Plug Power Inc. ("Plug") and Genesee County Economic Development Center ("GCEDC") respectfully submit the following answers and materials in response to public comments received at the June 20, 2022 meeting of the Town of Alabama (the "Town") Planning Board regarding the proposed substation project at the Science and Technology Advanced Manufacturing Park ("STAMP"). We sincerely appreciate the Town's efforts and attention to this vital project, which will make the region an epicenter of clean energy, innovation, and economic development.

The questions below (in bold), were provided in a July 4, 2022 memorandum from Robert D. Klavoon, PE of Wendel. Furthermore, we have attached the answers to questions from the Public Comment Session on May 16, 2022, which were previously submitted by O'Connell Electric Company, Inc., attached hereto as Exhibit A. Both Plug and GCEDC are available at any time to discuss any of these responses in more detail, prior to the July 25, 2022 meeting of the Town Planning Board.

STAMP - MASTER PLAN

WNY SCIENCE AND TECHNOLOGY ADVANCED MANUFACTURING PARK (STAMP)

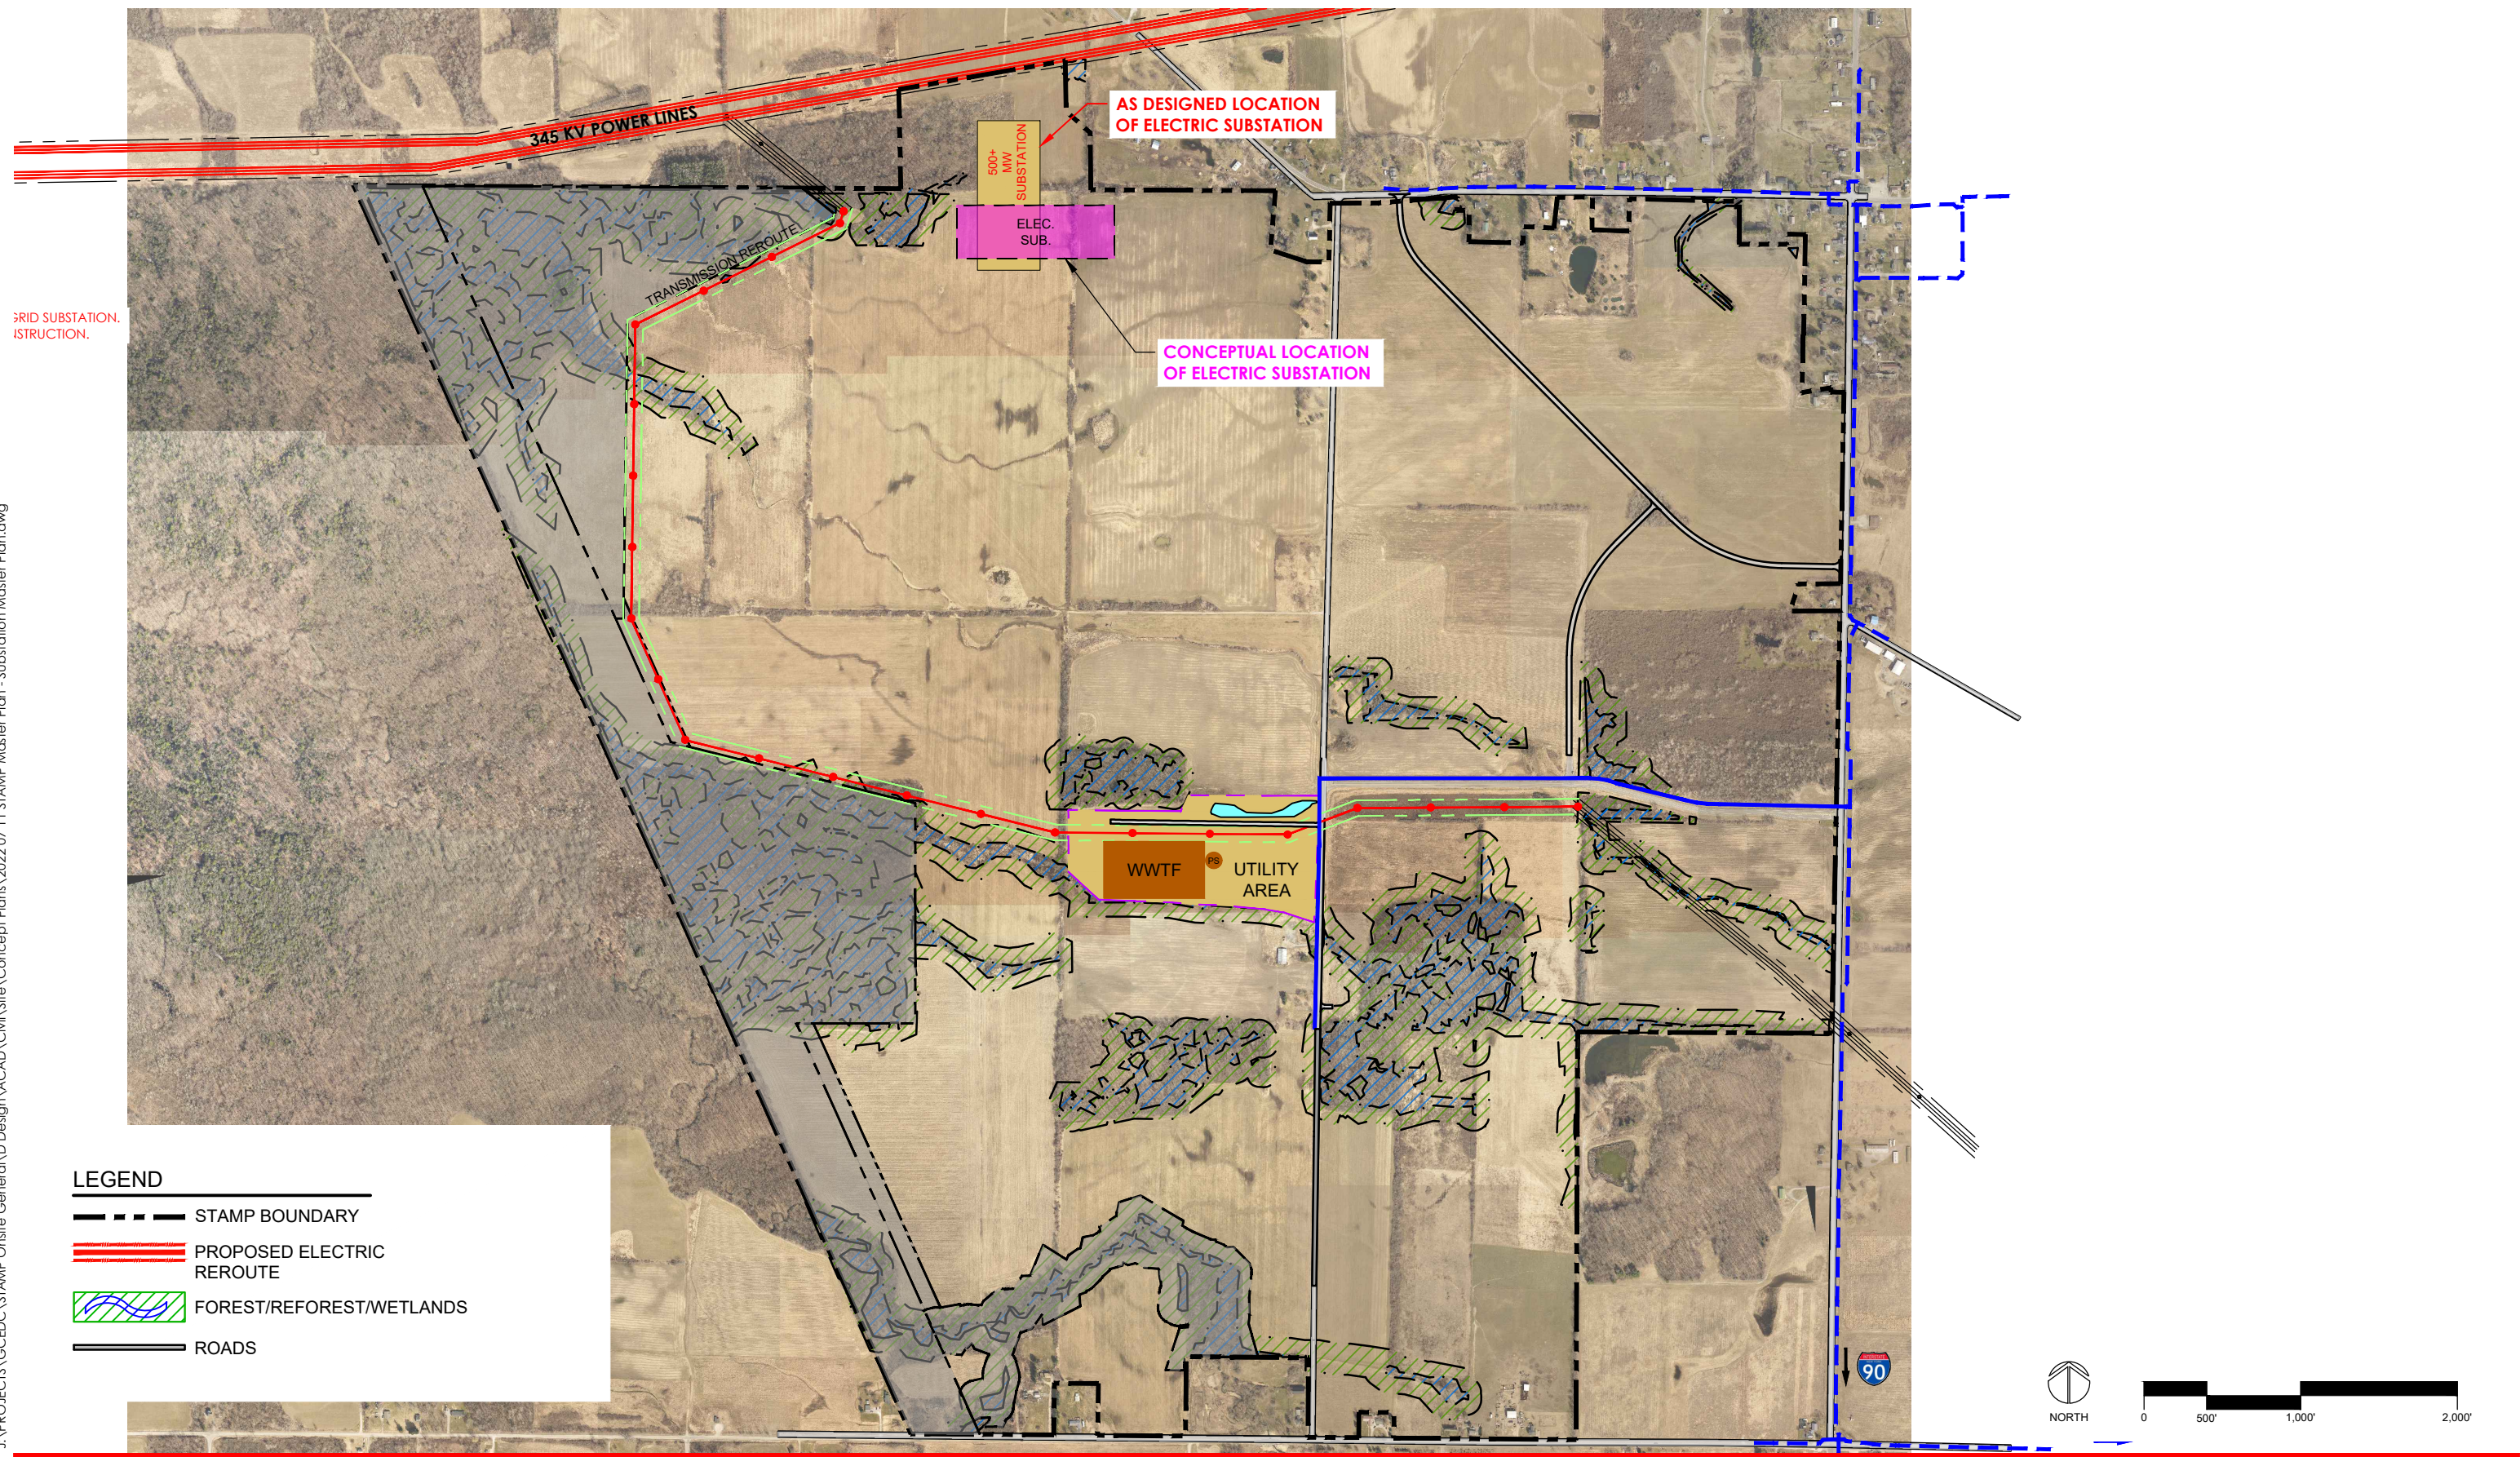
6. Please provide a clarification of the two types (and voltages) of power lines that will be present on site. Provide a clear exhibit that shows the limits of each line and ownership thereof.

Currently, two utility 345 kV transmission lines run past properties adjacent to the project site. The lateral lines that will feed the substation will also be 345 kV, and transverse towards the substation (away from neighboring properties). 115 kV lines will be located on the low voltage side of the substation and are far away from, and will not affect, homes in the vicinity.

DELINEATED WETLANDS AND STREAMS - UPDATED MARCH 2021
WMY SCIENCE TECHNOLOGY ADVANCE MANUFACTURING PARK
TOWN OF ALABAMA, GENESEE COUNTY, NY
MARCH 2021

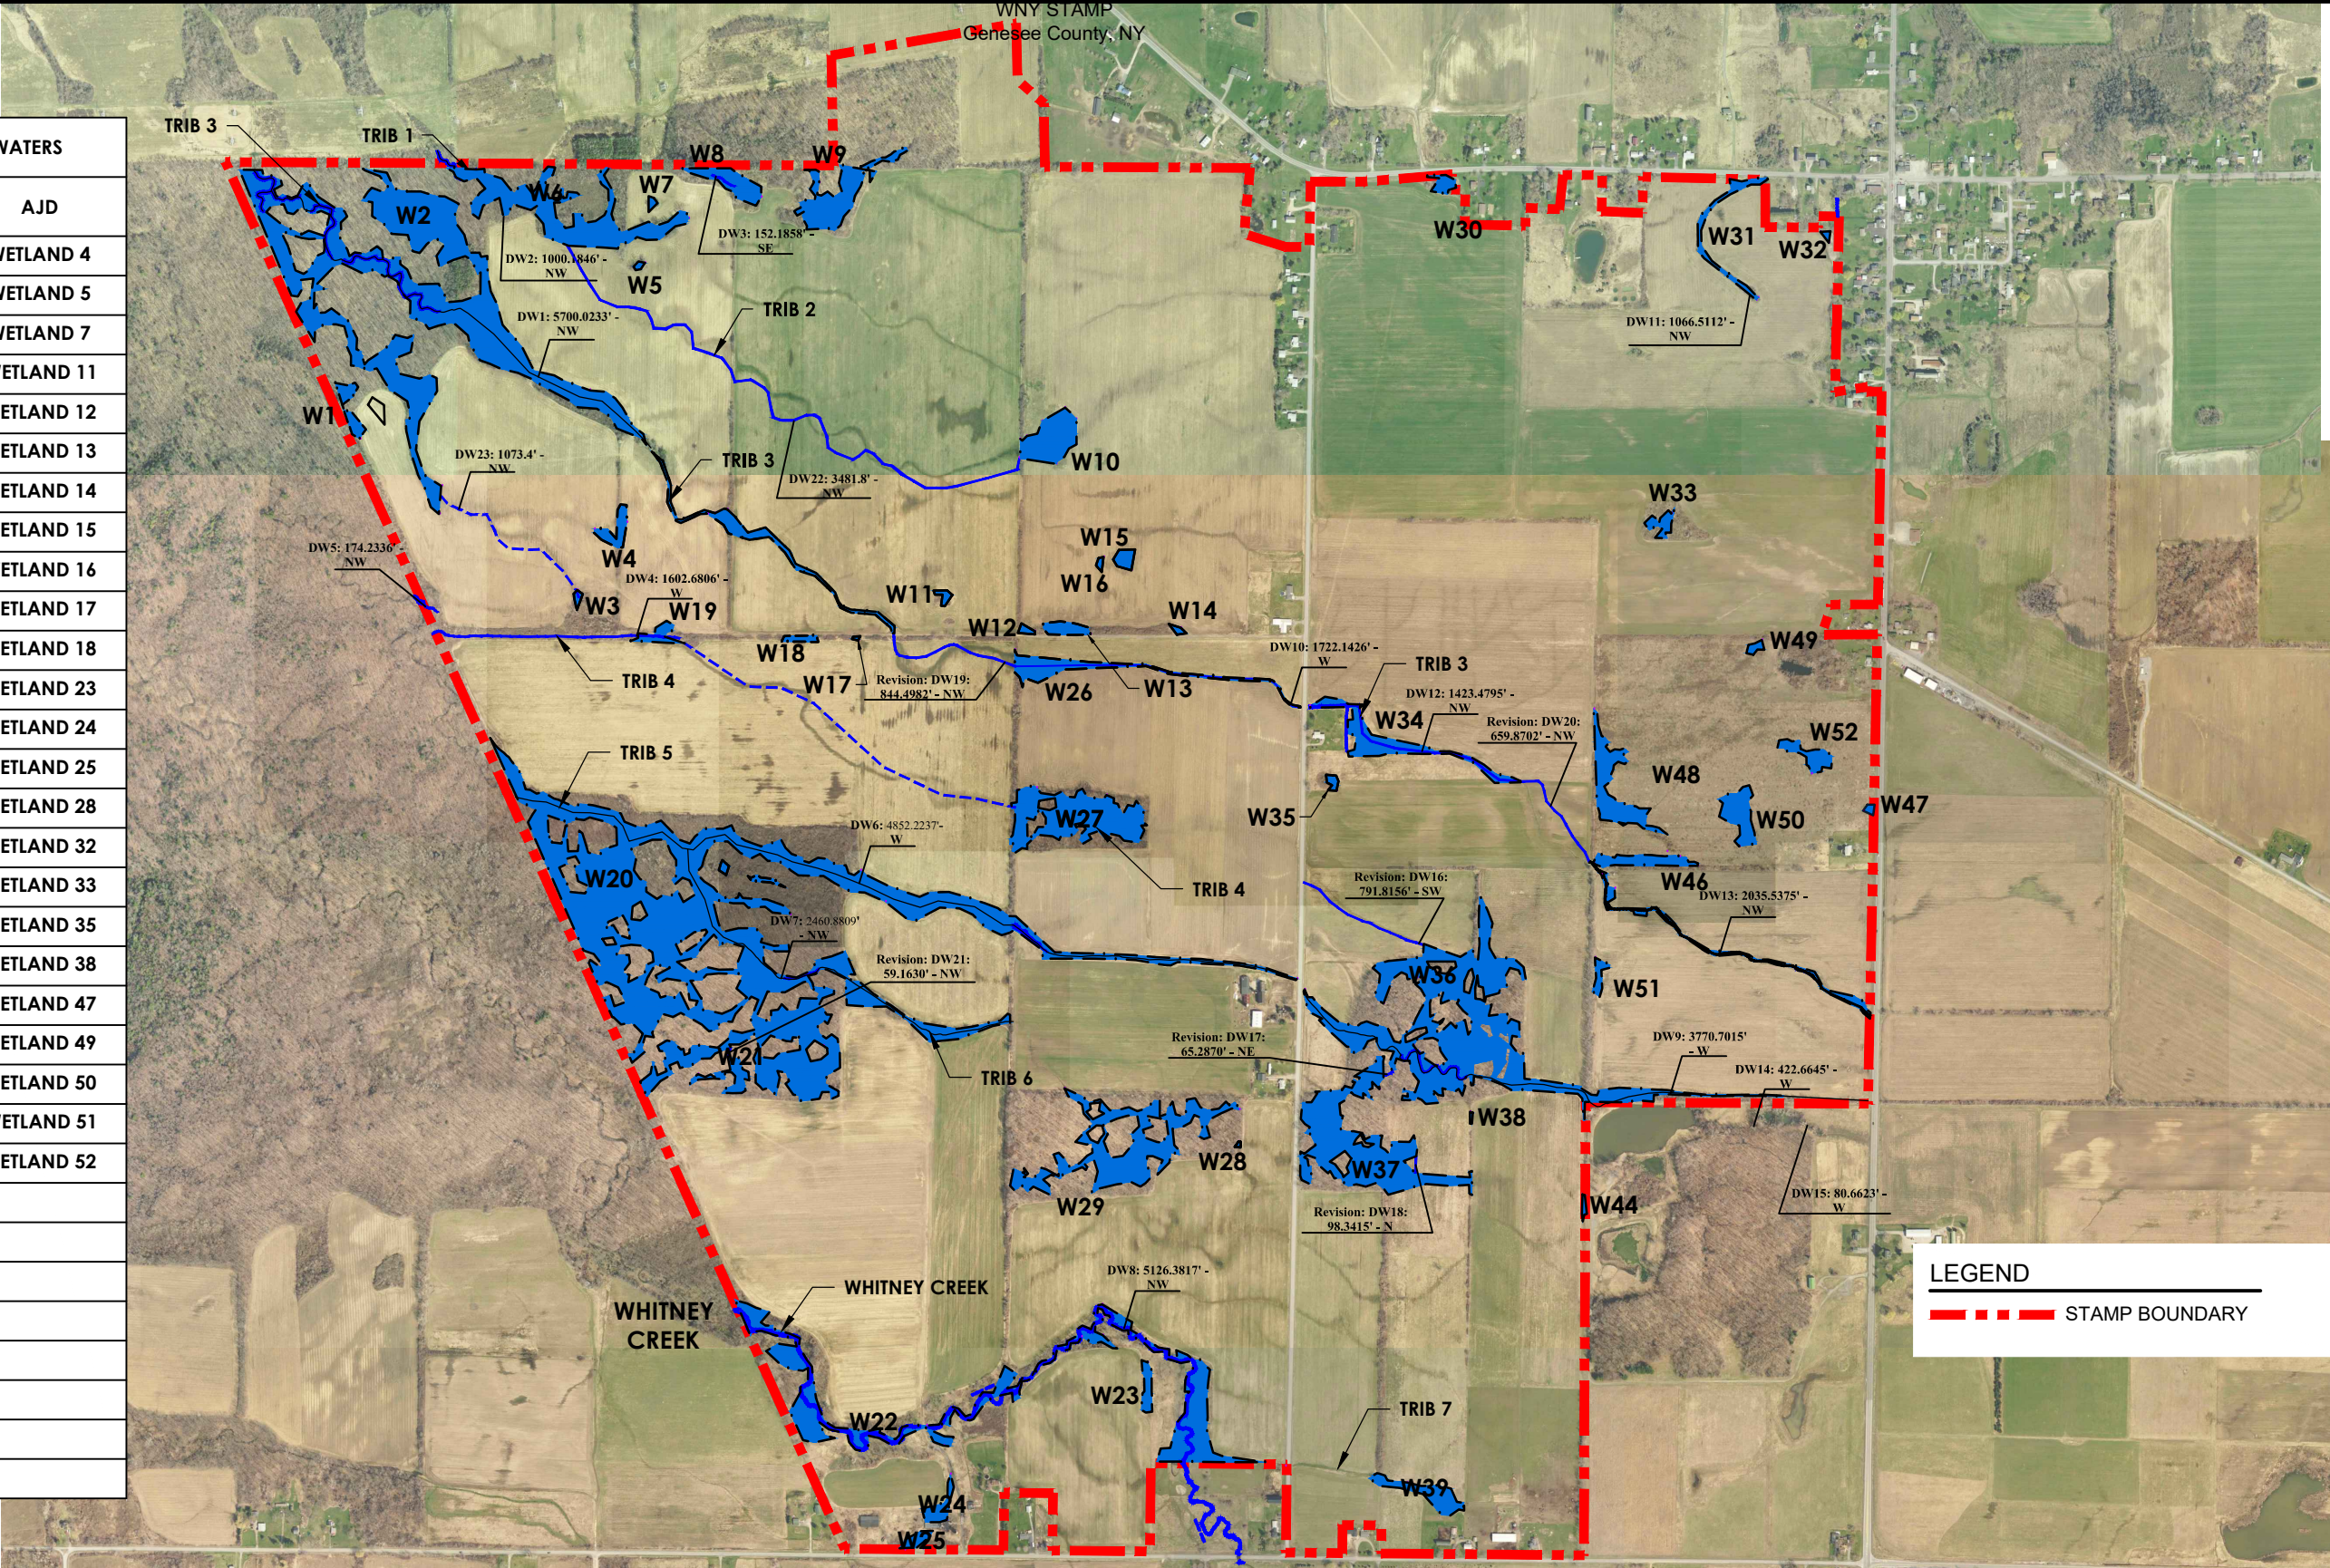
- c. Applicant to provide an overall STAMP site map that clearly shows the identified and approved NYSDEC/USACOE delineated wetland areas on the site.**

- d. Is the area where the substation was to be located now a NYSDEC/USACOE delineated wetland?**

Please see attached Exhibit B.

The previously proposed location of the substation potentially impacted wetland #9, as depicted in Exhibit B. The currently proposed footprint was specifically chosen, in part, to avoid wetland impacts. Please refer to Exhibit B for more detail.
